FINAL DRAINAGE REPORT
FOR
SADDLEHORN RANCH – FILING 3

July 13, 2023
Project No. 25142.05

El Paso County PCD File No.:
SF234

PERMANENT BMP APPLICABILITY MAP

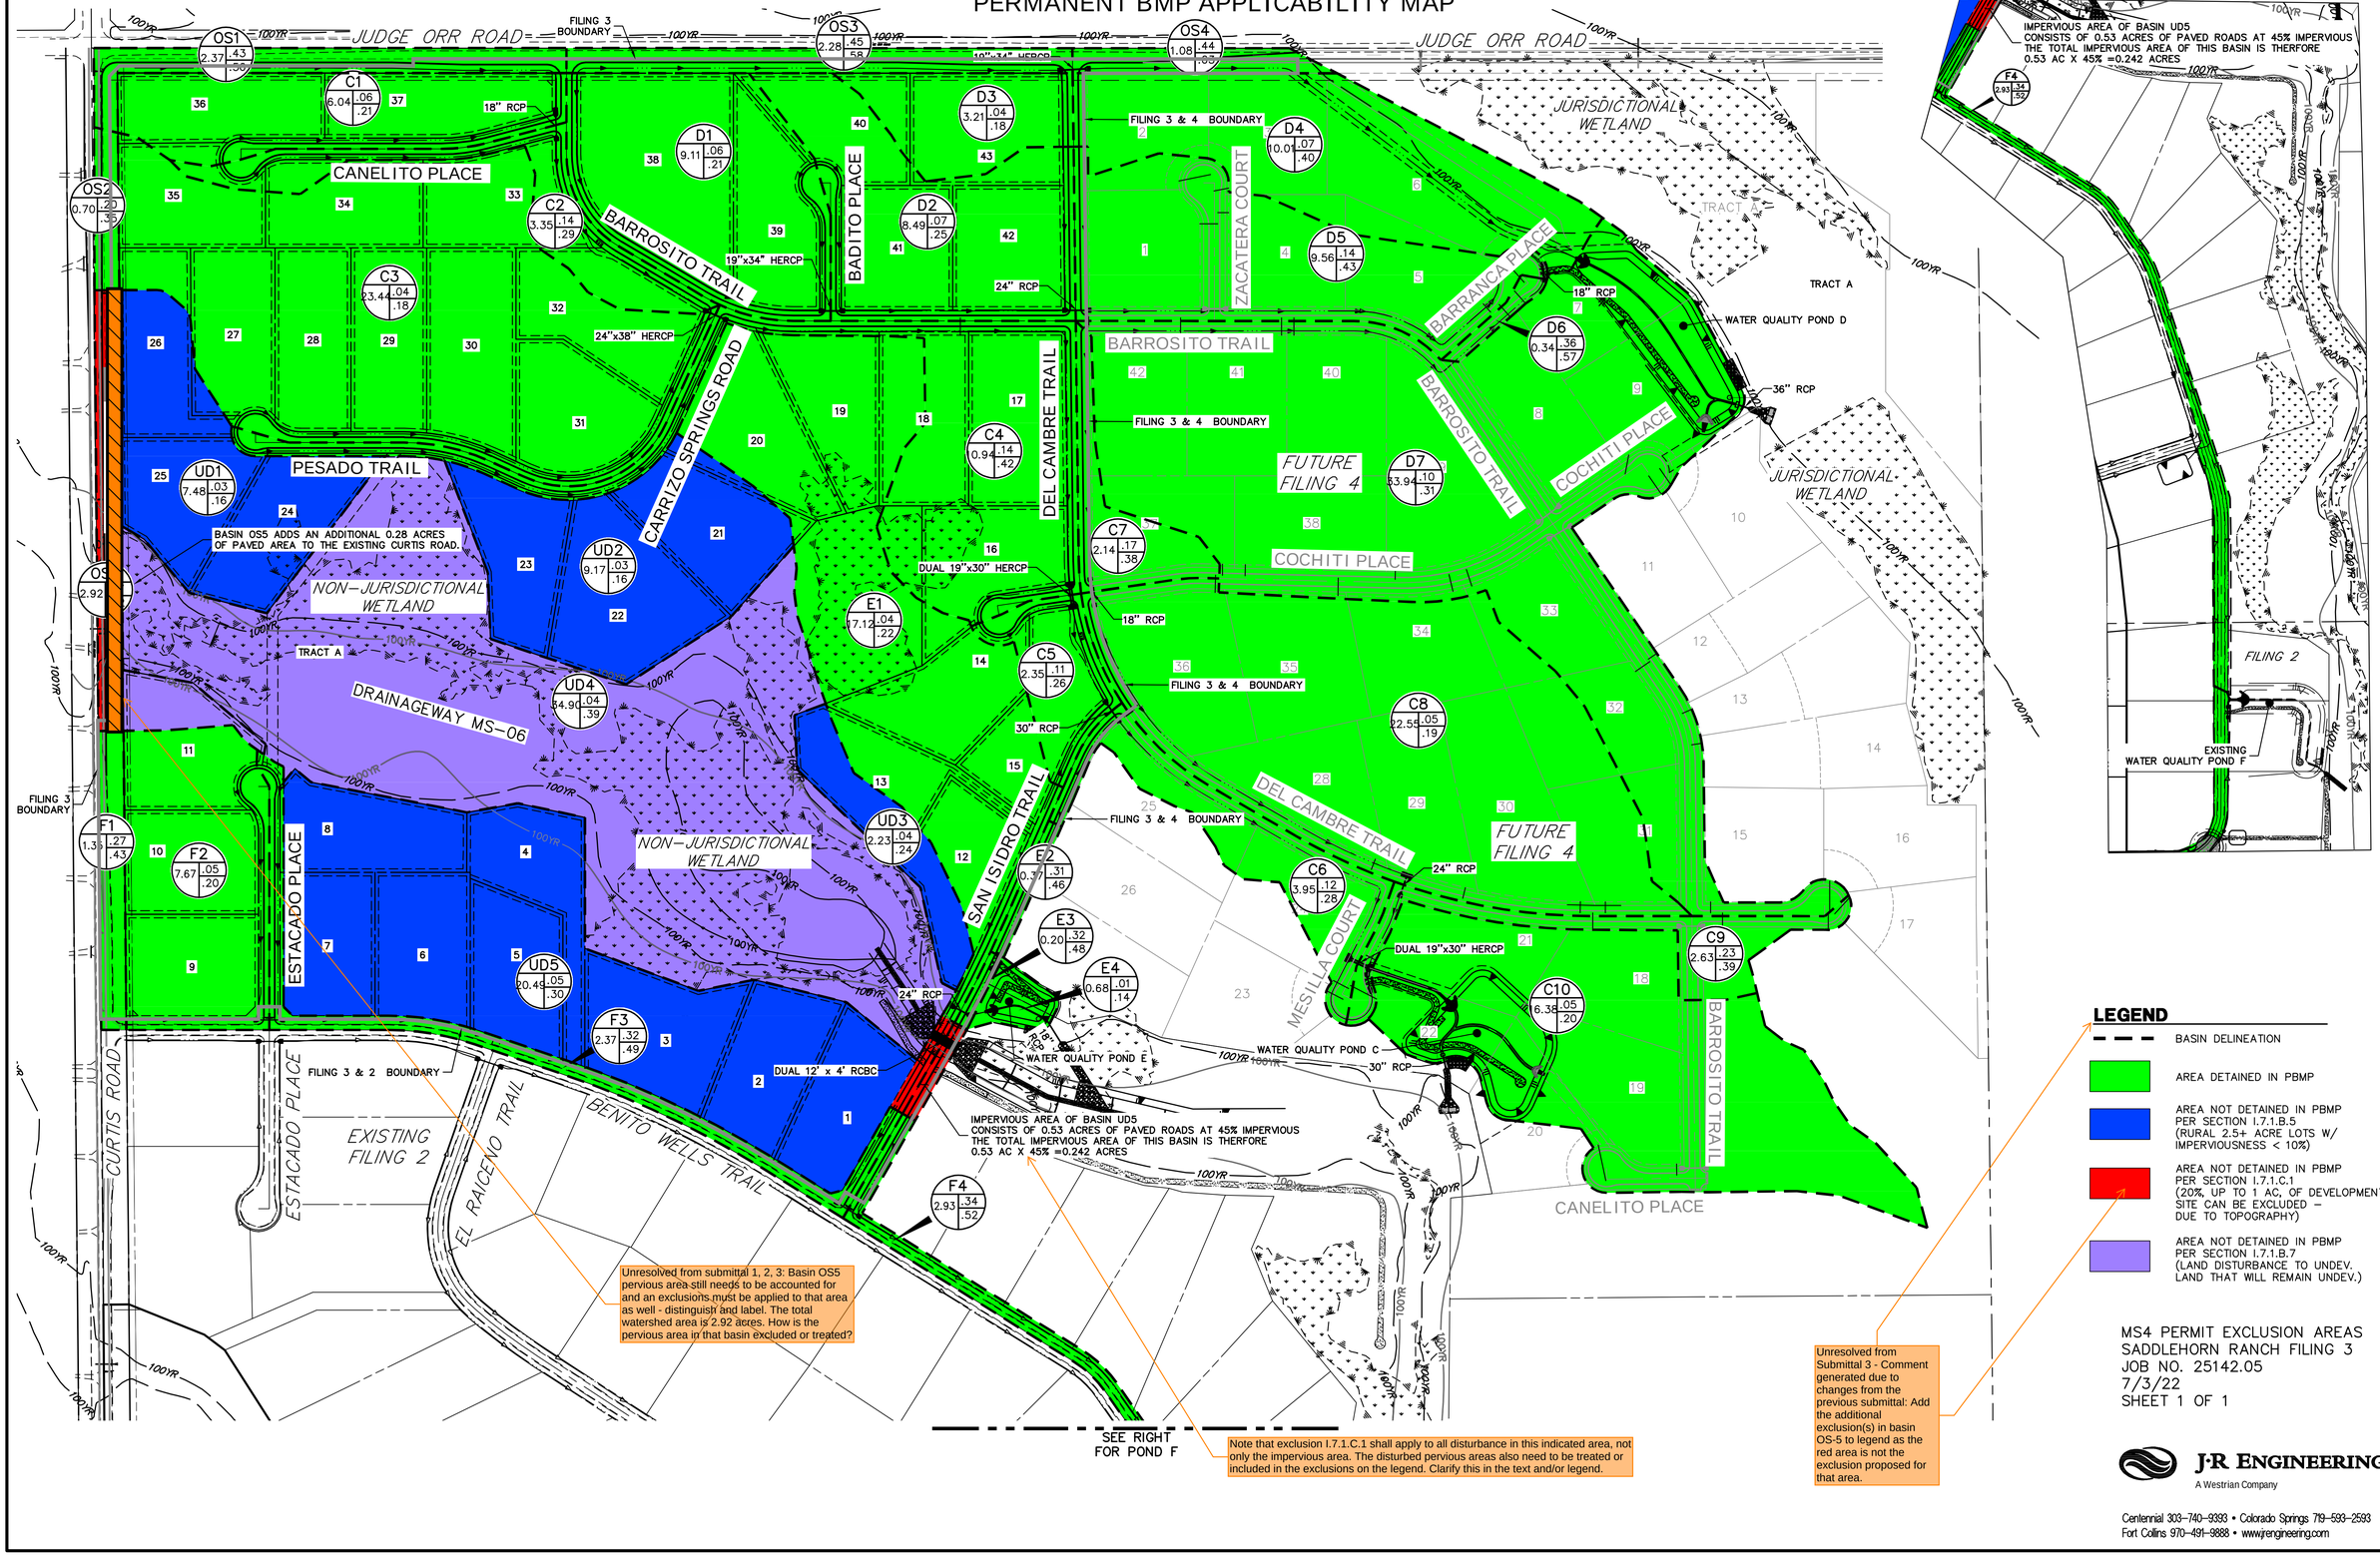
Unresolved from submittal 1, 2, 3: Basin OS5 pervious area still needs to be accounted for and an exclusions must be applied to that area as well - distinguish and label. The total watershed area is 2.92 acres. How is the pervious area in that basin excluded or treated?
